Staff Report – Planning & Zoning Item

Case No.: P-16-31 Request: Final Plat

Project: The Meadows ETJ – Final Plat

Re: Final Plat/ Plans of "The Meadows" Subdivision- City of Belton ETJ

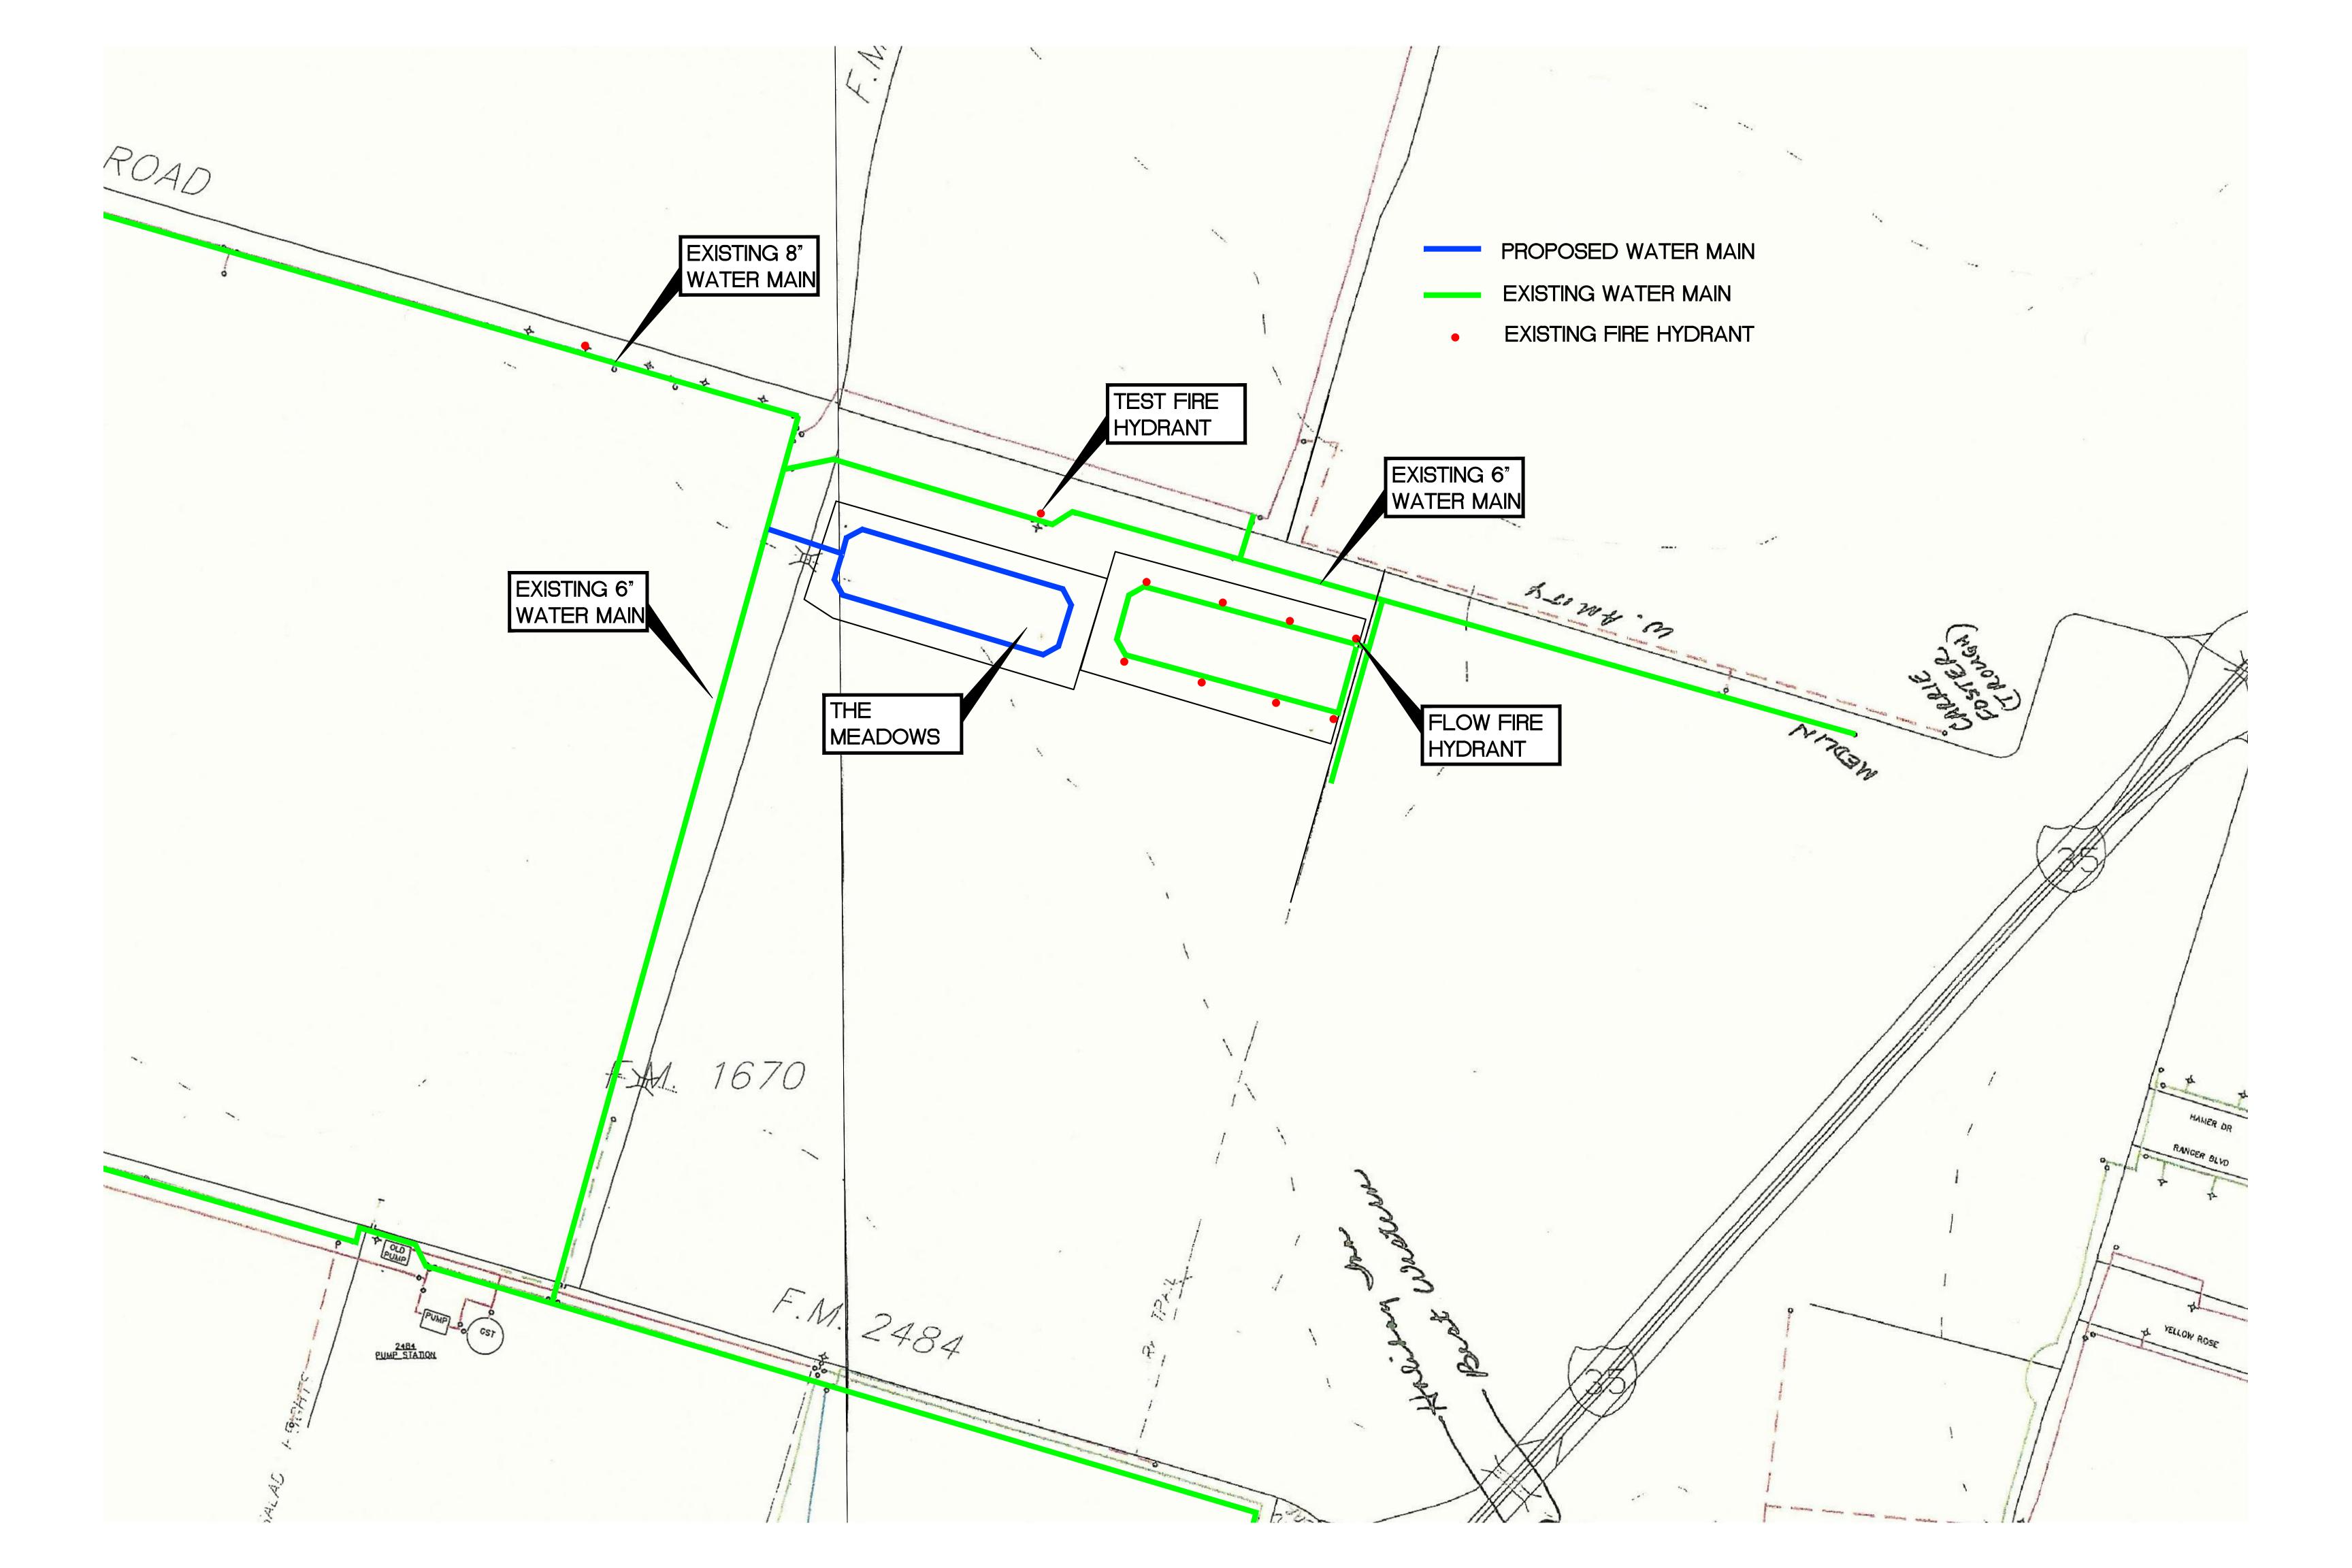
- 204.1- Street Names- 911 approval of the chosen street names is required.
- <u>204.5- Water- Include on the plat, the requested statement from Clearwater UWCD as outlined in their letter dated 7/22/2016.</u> (Item #2, 4)

- <u>204.11- Restrictions</u>- Provide a copy of any proposed restrictions or covenants that apply to this proposed subdivision.
- 204.15- Acreage & Length- Please breakdown the acreage & length statement by street.

- Verify the amount of signature blocks shown for the City of Belton on the plat. Also, the signature blocks for the City of Belton state that the proposed plat is "an addition to the City of Belton." Please verify.

- If the City of Belton agrees with, and allows the proposed offsite drainage easement/ detention pond for the increased storm water runoff generated by this proposed subdivision in lieu of onsite detention, Bell County requests a plat statement and signature block be placed on the plat indicating approval of the adjoining property owner receiving the additional storm water runoff. The plat statement and easement documents should clearly state which parties will be responsible for the maintenance of the offsite drainage area. The easement documents should be filed separately, and the recordation information should be included in the plat statement.

- Address all comments from the City of Belton.
